**SUBJECT: Police Headquarters WJE Clarification Letter – Phase 2 Peer Review Report – Life Safety Category**

**SUBJECT: New Police Headquarters — Phase 2 Peer Review**

Figure 3. Image from the file "2025311\_FLP Column H-2 and J-2 Validation.pdf" (dated March 11, 2025) prepared by the SEOR which indicates that they used a flexural stiffness modifier of 0.35 for reinforced concrete columns along Gridline 2

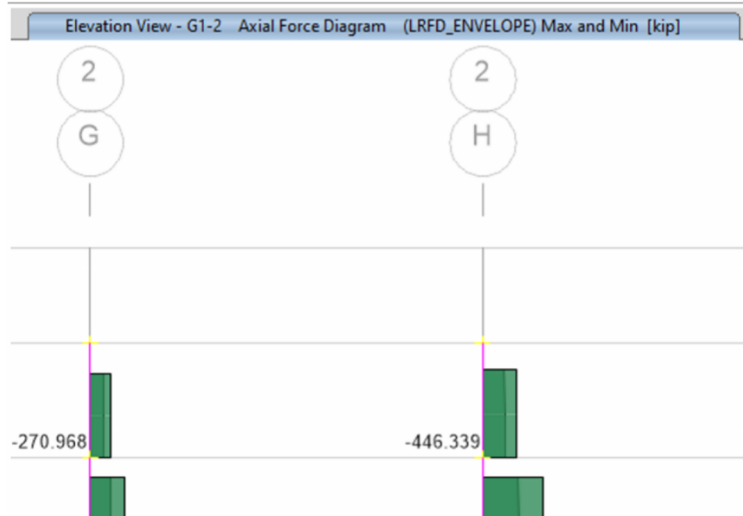
**Slab Stiffness Modifier.** We also do not agree that the slab stiffness modifier that the SEOR used in their numerical model properly reflects the behavior of reinforced concrete slabs. The reinforced concrete slabs are not uncracked at factored loading, for similar reasons as described previously for the concrete shear walls. It is further evident that the slab would not be uncracked at factored loading by the fact that cracks have already been observed and repaired near Gridline 2 (Figure 33). Since the distribution of forces in the FLPHQ is contingent on the stiffness of the diaphragm, the use of more appropriate stiffness modifiers may change the demands in the CMU walls. Given that the demands in those walls are already close to their design capacity (based on the SEOR’s calculations), it is not evident that the walls will have sufficient capacity after the modifiers are updated.

Figure 4. Detail 7 from Sheet HQ-S7-1-02 which shows CMU wall bearing on thickened slab-on-ground. Note that there is a vapor retarder under the slab-on-ground supporting the partition masonry walls

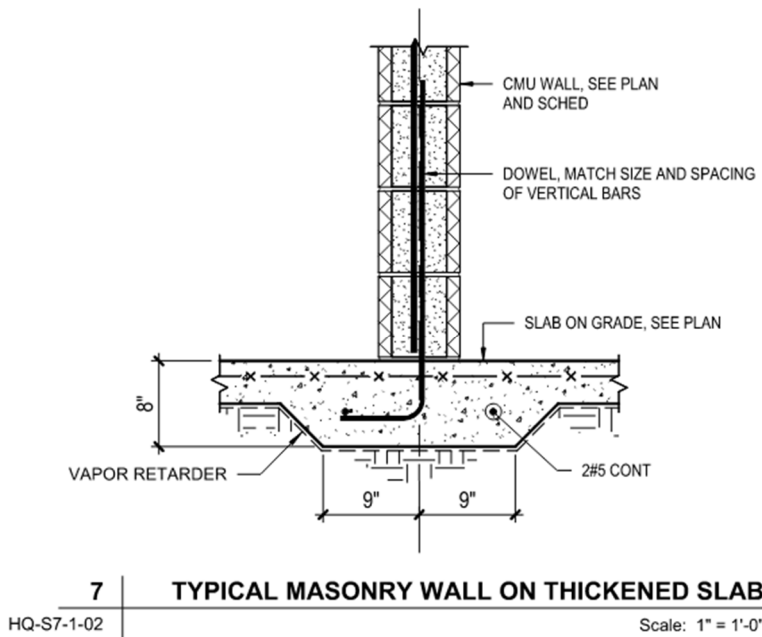
On numerous sheets in the structural drawings (e.g., Sheet HQ-S2-2-1A), the CMU partition walls are referred to as “non-loadbearing CMU” which bear on thickened slab built over a vapor retarder (Detail 7 of Sheet HQ-S7-1-02). A vapor retarder would reduce the sliding resistance of the wall.

**Masonry Wall Connection Details at Top and Bottom of Wall.** Both 7/HQ-S7-1-02 (Figure 4) and 2/HQ-S6-1-01 (Figure 5) indicate that the vertical reinforcement at the bottom of the CMU walls should be lapped with dowels. These dowels were to extend into the footing, or thickened slab, and be hooked. At the top of the CMU walls, two details are provided on Sheet HQ-S7-1-02, which is labeled as “Typical Masonry Details”. Detail 3/HQ-S7-1-02 appears to be a detail for use with CMU walls that are bearing walls. A note in this detail also indicates that this detail applies when tie-beams are referenced on plan. We did not observe any tie beam references on plan, and we also did not observe on the plans where any CMU walls were explicitly designated as bearing walls. As such, Detail 3/HQ-S7-1-02 appears to not be applicable to the interior masonry walls. A wall schedule shown on HQ-S6-1-01 (see Figure 6) also does not explicitly designate any of the CMU walls as bearing walls. The masonry shaft noted above would necessarily be a bearing wall as it supports the end of concrete joists, but all other walls (not within Area E) appear to be non-loadbearing walls and in fact are believed to have been constructed as infill after the concrete structure was built.

**Report No. 087, Dated January 8, 2024:** The TI notes that “SOG pour 4 rebar. Dowels for CMU wall need to be rearranged [sic] so that the compy [sic] with detail 7/HQ-S7-1-02 for typical masonry wall on thickened slab.” The TI also notes: “On CMU wall on lvl 1 area A grid line 4, rebar needs to be extended to the bottom of lvl 2 slab. See image on next page.” See photographs from the report in Figure 19.

Figure 5. Detail 2 from Sheet HQ-S6-1-03 which shows CMU wall foundation for wall footings that have WF# designation on the foundation plans. Note that the vapor retarder under the slab-on-ground does not pass under the wall footing

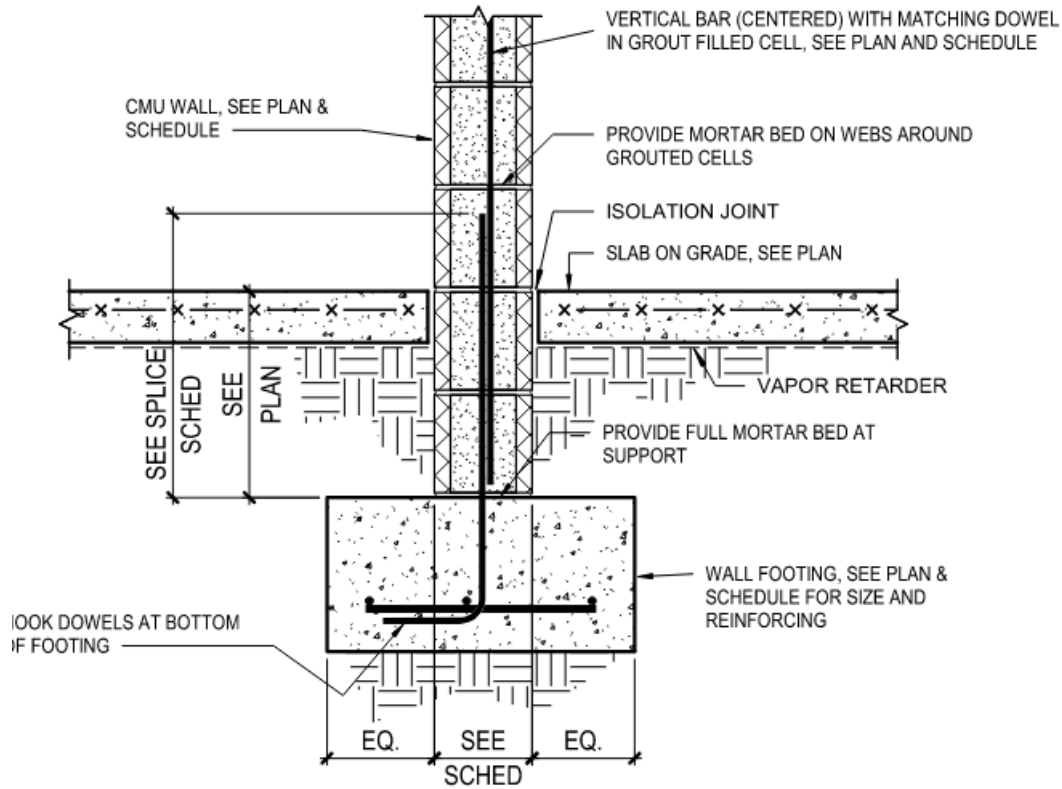
Furthermore, it is evident that the SEOR is aware of what good practices are for designing masonry shear walls, evidenced by the east-to-west spanning wall used in Area E. Unlike the partition masonry walls, that wall a) was constructed such that axial and diaphragm loads from the roof can be transferred to the wall (Figure 23), b) has vertical reinforcement that is well-anchored to develop shear-friction resistance (Figure 11), and c) has a standalone wall footing without a vapor retarder underneath it, thereby increasing the sliding resistance of the wall (Figure 5).

Figure 7. Detail 6 of Sheet HQ-S7-1-02 which shows two options for connecting the partition CMU walls to the elevated slabs or beams

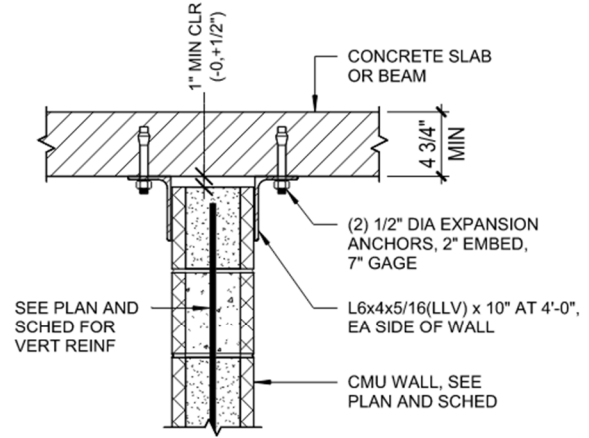
None of the connections of the partition masonry walls (i.e., not including the bearing wall in the community room and the masonry core wall in the main structure) to the diaphragm shown in the structural drawings (Detail 6 of Sheet HQ-S7-1-02) or noted in the special inspection reports (i.e., PTA anchors) satisfy ACI 318-14 Section 12.5.3.7. In other words, these connections do not satisfy the shear-friction provisions of ACI 318, which invalidates the masonry walls as code-compliant contributors to lateral resistance.

Furthermore, the alternate option provided in Detail 6 of Sheet HQ-S7-1-02 shows a minimum gap of 1 inch between the top of the walls and the bottom of the above floor. Should this detail have been used, the walls would only start resisting floor loading once (or if) the gap closed, clearly indicating that the SEOR did not originally intend for the walls to carry axial loading from the above floor. In their recent lateral system calculations package (dated almost three years after issuance of the permitted structural drawings), the SEOR indicated that axial load in the walls was requisite to develop the sliding resistance of the so-called “CMU shear walls.” It is confounding that the SEOR would propose using a connection detail that effectively precludes axial load from entering the wall (apart from self-weight) if their design relied on sliding resistance, unless of course, the original design did not intend for those walls to be a part of the lateral system of the structure.

Detail 6/HQ-S7-1-02 (Figure 7) is further divided into two details, a typical detail that applies to both interior and exterior walls and an alternate option that applies to interior walls only. The typical detail shows the vertical reinforcement of the CMU wall embedded into the slab above. No minimum embedment depth is provided, but the details note that the slab thickness must be a minimum of 4 ¾ inches. Section 042200 of the specifications, “Concrete Masonry Units” Part 2.6.C addresses “Top of Wall Anchors.” This specification section is shown in Figure 8. Interior non-load bearing partition walls in Seismic Design Category A, which applies to the FLPHQ, are shown to allow PTA series anchors by either Blok-Lok or by Hohmann & Barnard (H&B). A specification sheet for PTA 420 HS anchors by H&B is shown in Figure 9. A lateral load capacity for the anchor is not provided on this sheet nor is the type of fastener (e.g., screws) required to connect the anchor to the concrete structure above. It may be that this information exists somewhere else on H&B’s website, but we could not find it. As such, it is unclear to us if these anchors are approved or rated for lateral load transfer, and if so, what load they are rated for. Also unclear is the capacity that the SEOR assumed for these anchors. A rendering of the PTA 420 HS anchor at the top of a CMU wall (also taken from H&B’s website) is shown in Figure 10. Note that the anchor is shown with the length of the top plate oriented transverse to the length of the wall, suggesting that its rated capacity would be applicable to out-of-plane rather than in-plane loading.

**Diaphragm Shear Transfer.** The lateral load calculations package does not address whether the connections between the concrete floor diaphragm and masonry walls are adequate to transfer shear from the diaphragm. Detail 6 of Sheet HQ-S7-1-02 (Figure 7) of the structural drawings indicate two details for connecting the masonry walls to the slab or soffit beams. The first option (the “typical detail”) entails embedding the vertical wall reinforcement several inches into the diaphragm. Lateral load from the diaphragm might thereby be presumed to be transferred into the CMU walls through shear friction. However, Section 22.9.5.1 of ACI 318-14 requires that shear-friction reinforcement be developed on both sides of the friction interface, which the reinforcement in the wall is not, since per Section 25.4.2.1, the bars must be embedded at least 12 inches to develop the bar, which they are not. Therefore, this detail

does not comply with the ACI 318-14 code if its intent is to transfer diaphragm shear through shear friction. The second option shown in Detail 6 (the “alt. option”) entails anchoring two angles into the diaphragm on either side of the wall, presumably to laterally brace it. Since the angles are not anchored into the wall in the detail, lateral load from the diaphragm cannot be transferred into the walls. Moreover, a gap with a minimum thickness of 1 inch is shown between the top of wall and bottom of diaphragm, the intent of which appears to have been to preclude the wall from receiving diaphragm shear and floor gravity loading until the gap closes. Additionally, various threshold inspection reports (e.g., No. 123) show PTA 420 HS anchors (produced by Hohmann & Barnard, Inc.) which are post-installed into the soffit beams and slabs using Tapcon screws and tied to the vertical reinforcement from the CMU walls (Figure 17, Figure 20, Figure 26, and Figure 27). This connection cannot reasonably transfer diaphragm shear into the walls either. Threshold inspection report No. 80 notes “CMU walls to be braced to the soffit beams using PTA 420 HS anchors as per approved summittal [sic] #0422000-13.0 instead of detail 6/HQ-S7-1-02,” suggesting that these anchors were used for most connections of CMU walls to soffit beams. For these reasons, we recommend that the SEOR provide calculations for review demonstrating that the wall-to-diaphragm interface connections are adequate to transfer shear from the slabs into the walls.

Figure 27. Photograph from Threshold Inspection Report No. 125 showing PTA connectors at bottom of soffit beam with the two screws attaching the plate of the anchor to the soffit beam

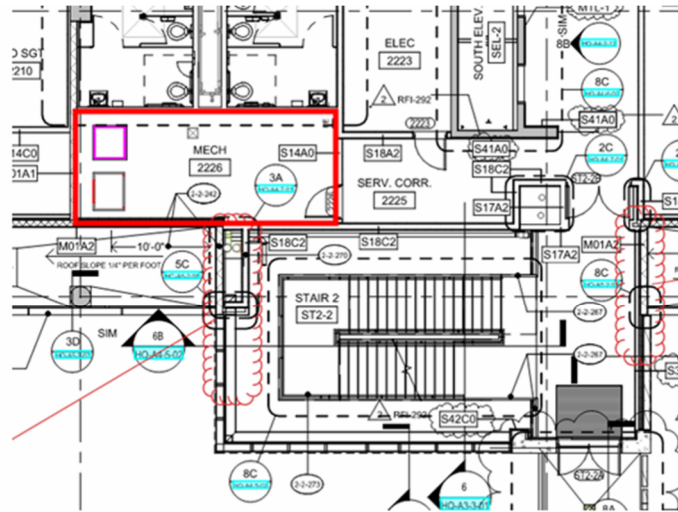
**Report No. 125, Dated November 27, 2023 (Note that Report No. 124 is dated March 6, 2024 and Report No. 126 is dated March 12, 2024):** The TI notes that “Confirmed that vertical reinforcement anchors are being tied as per specification using two tapcon screws instead of one.” This statement appears to refer to the TI's comment in Report No. 123 above. A photograph of this condition was provided (Figure 27).

Figure 29. Photographs from Threshold Inspection Report No. 133 showing CMU wall at Level 1, Area D

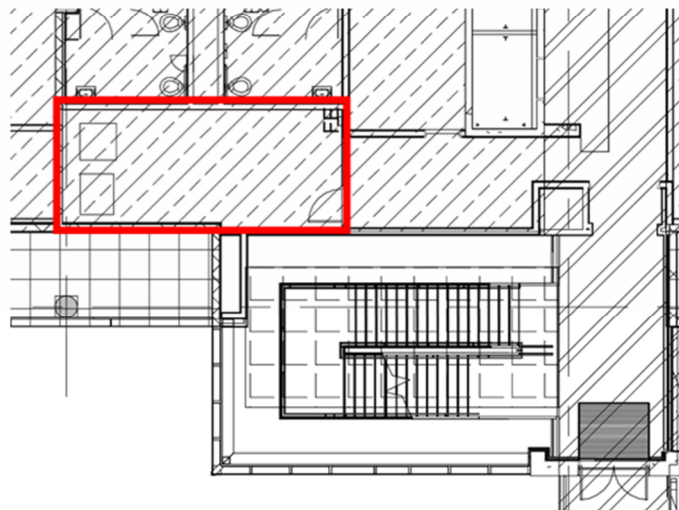
**Report No. 133, Dated March 21, 2024:** The TI notes that “Inspection of CMU on Level 1 area D between grid lines 15 and 16. Checked anchors are properly installed and rebar tied to them.” See Figure 29.

Figure 31. Cross-section of soffit beam (Sheet SC-3C-D of Submittal 328) showing 1.5 inches of cover to the transverse reinforcement

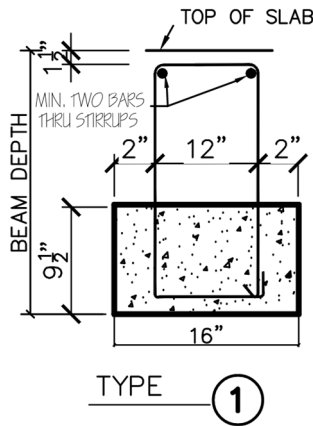
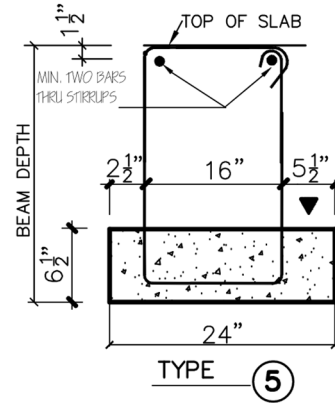
**Durability.** The cover depths shown in the structural drawings satisfy code-prescribed minimum values. However, the dimension lines shown in the precast concrete shop drawings (e.g., Sheet SC-3C-D of Submittal 328) were inconsistent and implied different cover depths. Figure 31 and Figure 32 illustrate one example of this inconsistency. For the first detail (Figure 31), the 1.5-inch dimension was drawn from the top of slab to the transverse reinforcement. For the second detail (Figure 32), it was drawn from the top of slab to the center of the top longitudinal reinforcement such that there was approximately zero inches of cover to the transverse reinforcement. We are unable to ascertain if what was constructed conforms to the cover requirements set forth in Figure 31 or Figure 32.

Figure 35. Sectional view of a reinforced concrete column which is enlarged to increase resistance. Note that the new transverse reinforcement should be spaced closely to provide confinement

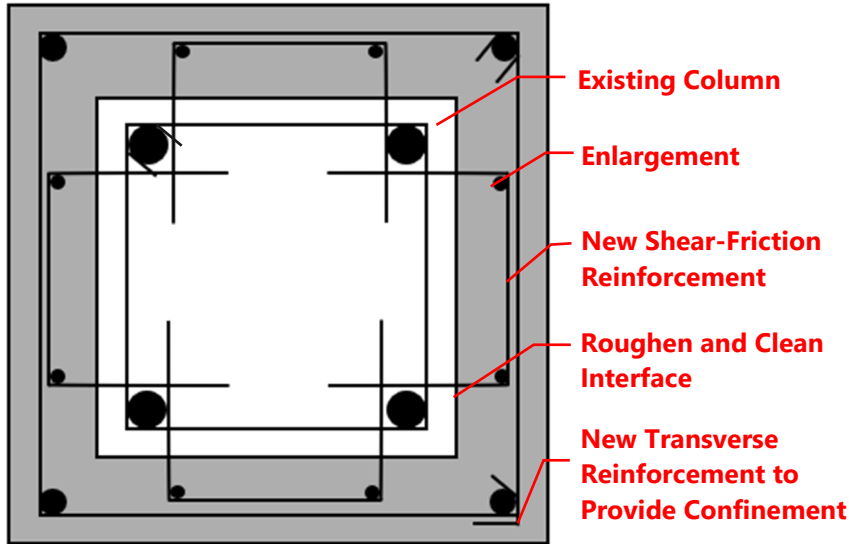
The cross section of the column can be enlarged to strengthen the column for both combined axial and flexural loading and for shear. Figure 35 conceptually illustrates the enlargement of a reinforced concrete column. Since it will be difficult to anchor new flexural reinforcement at the top and bottom of the columns due to the presence of potentially conflicting reinforcement in the soffit beams, the flexural strength of the column can be enhanced primarily by increasing the effective depth of the section rather than by adding flexural reinforcing steel.

Enlarging the cross section as shown in Figure 35 provides an added benefit of confining the concrete in the original column. When concrete is confined it has a greater strain capacity, thereby increasing the strength and ductility of the column, even without additional anchored vertical reinforcement.

In the column enlargement rectification shown in Figure 35, the perimeter of the existing column is roughened and cleaned to allow for composite action with the enlargement. New shear-friction reinforcement is post-installed into the existing column to enhance interface shear strength between the original column and the enlargement. For columns that are overstressed in axial-flexural loading, the new transverse reinforcement should be spaced closely to provide confinement. For other columns, the new transverse reinforcement need only be spaced more closely than one-half the effective depth of the column. We expect that using No. 4 reinforcing bar ties at this spacing will meet the minimum shear reinforcement provisions in ACI 318-14.

Figure 36. Sectional view of a reinforced concrete column which is wrapped with FRP to enhance shear strength and member deformability

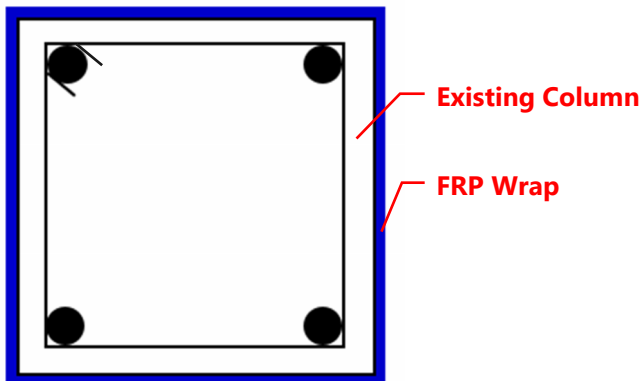
Fiber-reinforced polymer (FRP) jacketing of the columns may also be a viable option to rectify the axial-flexural and shear conditions previously identified. As illustrated in Figure 36, this rectification entails wrapping a column with FRP and adhering it using epoxy. FRP jacketing can be used to provide

Figure 37. Section view of a reinforced concrete beam which is enlarged to increase flexural resistance

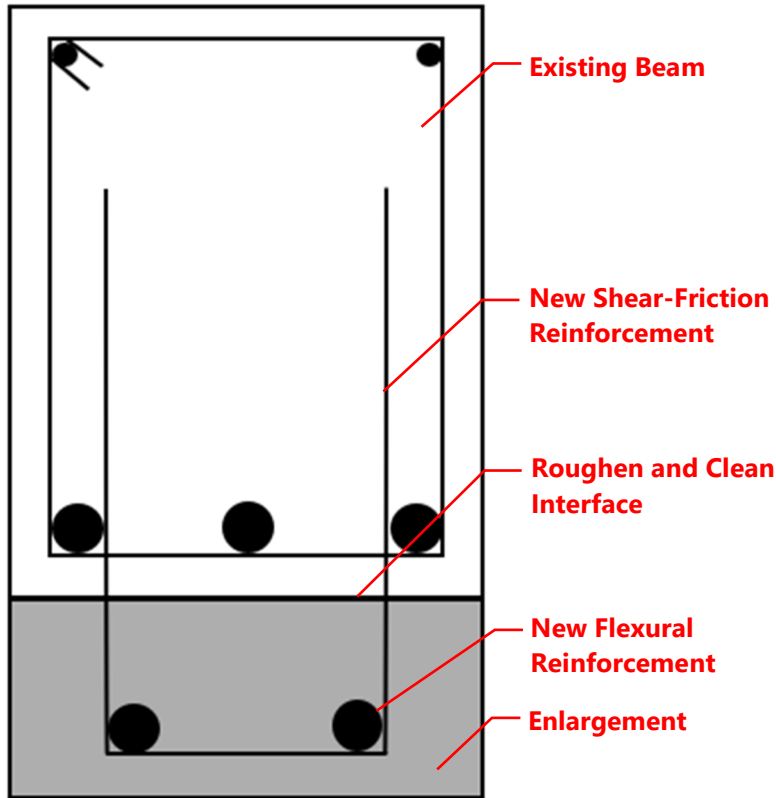
Enlarging the overstressed beams can enhance their flexural strength, similar to the upturned beams on roof soffit beams RSB 76 and 79. A conceptual illustration of this type of rectification is shown in Figure 37. The tension-face of the existing beam is roughened to allow for sufficient interface-shear strength with the new enlargement. Post-installed U-shaped ties embedded (at least one development length on either side of the interface) are provided to enhance interface-shear strength. Adequately anchored tension reinforcement is provided in the enlargement to increase flexural resistance of the beam.

Figure 38. Section view of a reinforced concrete beam showing strengthening with near-surface mounted reinforcement (adapted from ACI 440.2-23)

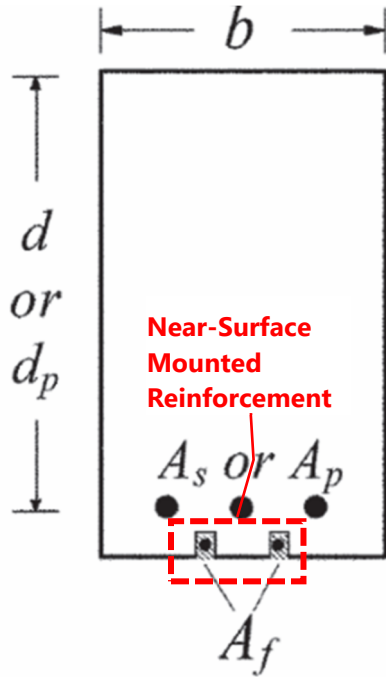
Similar to beam enlargements, a near-surface mounted (NSM) rectification entails providing new longitudinal tension reinforcement to increase the flexural strength of the overstressed beams. As shown in Figure 38, grooves are cut into the existing beam to receive the new reinforcement. The substrate within the groove should be properly prepared to enhance bond strength with new epoxy or cementitious paste which is placed in the groove with the reinforcement. Steel reinforcement may be used, although non-metallic reinforcement or corrosion-resistant metals may be preferable to mitigate the risk of corrosion.

Figure 39. Section view of a reinforced concrete beam strengthened with an externally bonded FRP laminate (adapted from ACI 440.2-23)

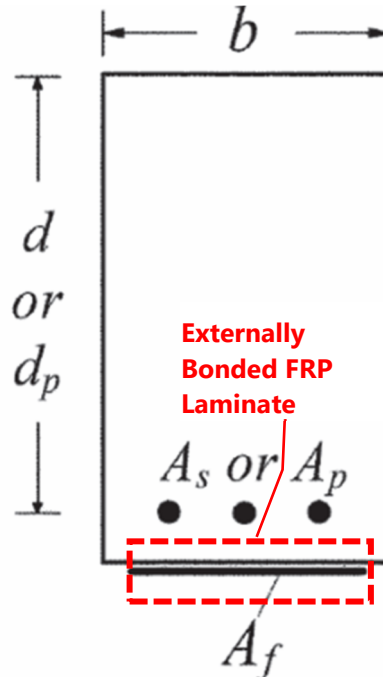
Other externally bonded systems may be utilized to increase the flexural resistance of a beam. ACI 440.2-23 also provides guidance for designing other external FRP systems, such as bonded laminates (Figure 39). Otherwise, a steel plate may be bonded to the beam but would likely require fireproofing. No matter the system used, sufficient anchorage of the external system should be provided such that it may develop its intended strength at the critical regions requiring strengthening.

Figure 40. One potential location for the proposed new reinforced concrete shear wall

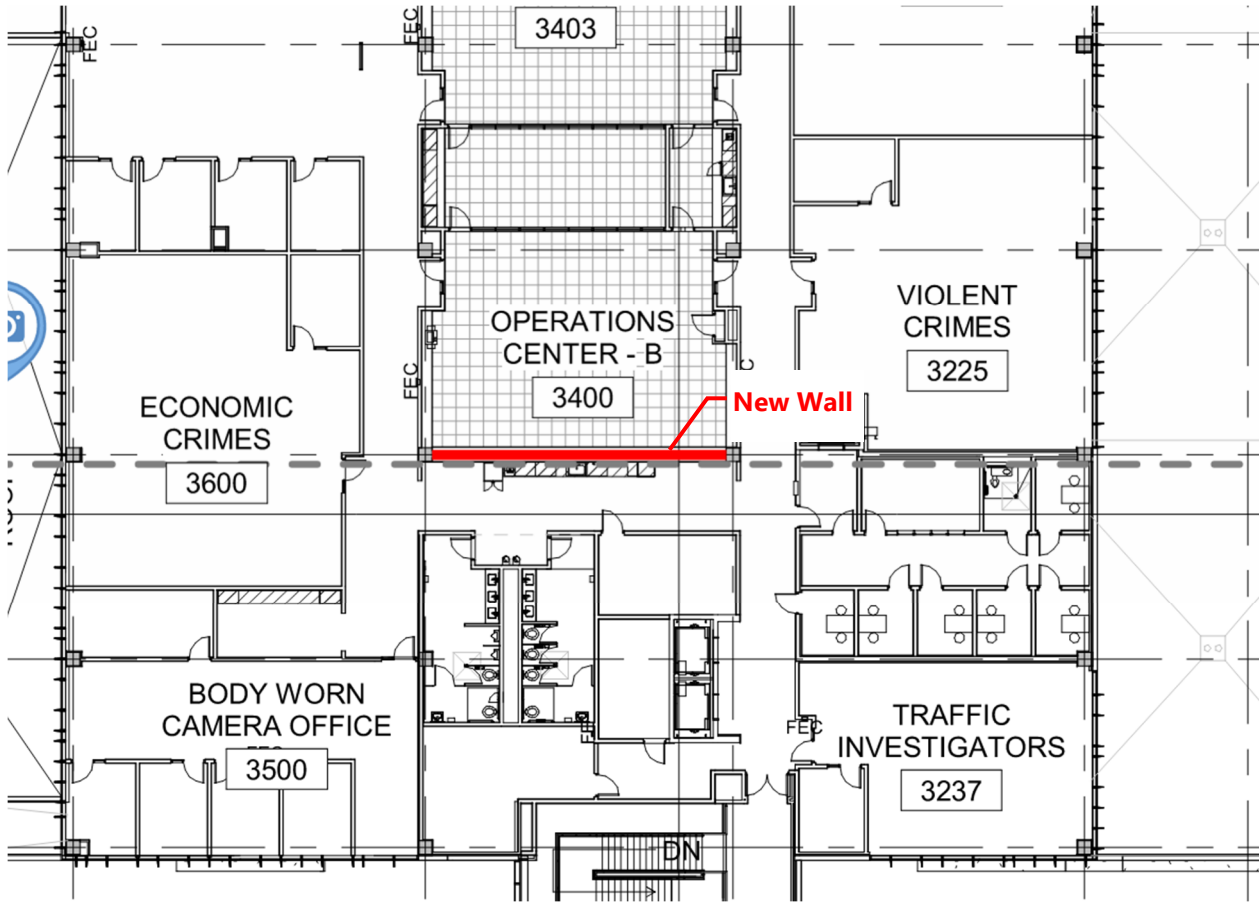
The addition of a shear wall at the location recommended in Figure 40 will not fully rectify the sliding deficiency of mat footing CF-1 (under the north stair shaft). One way of enhancing the sliding resistance of this footing is to connect or tie it to adjacent column spread footings, as illustrated in Figure 41. If CF-1 is connected to the column spread footings at Grid Points J/3, K/3, and K/4, the additional gravity load on these columns will provide additional frictional resistance against sliding resistance for the combined foundations. To connect the footings, new segments of reinforced concrete foundations can be cast. These new tie footing sections should have sufficient strength to transfer the lateral sliding loads from the mat footing and column spread footings. The new tie footings would also need to be reinforced to preclude other limit states such as (e.g.,) one-way shear.
